Breakout Board Errata Memo

ECE 492 - Spring 2015

This memo will detail the physical errata associated with the layout of the LFEV - 2015 TSV system's Breakout Board (BoB).

Figure 1. Errata 1.

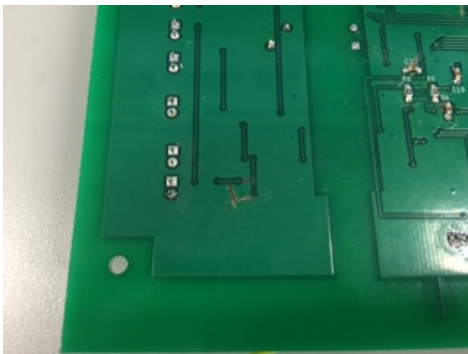
1. Isolation of the through hole near U6 and L2.
2. Isolation of the through hole near C2.
3. Isolation of multiple through holes near U1, U8, and U11.
4. Missing connection between U17 the AMS I2C port.

NOTE: All errata have been corrected in the most updated versions of the Gerber files and schematics for the BoB, as well as having been physically fixed by William Stathis on the working BoB used in LFEV TSV 2015's system. Ordering new boards for future use will require no changes to be made; however, if future teams wish to utilize the 4 boards we purchased in 2015, these errata should be handled.
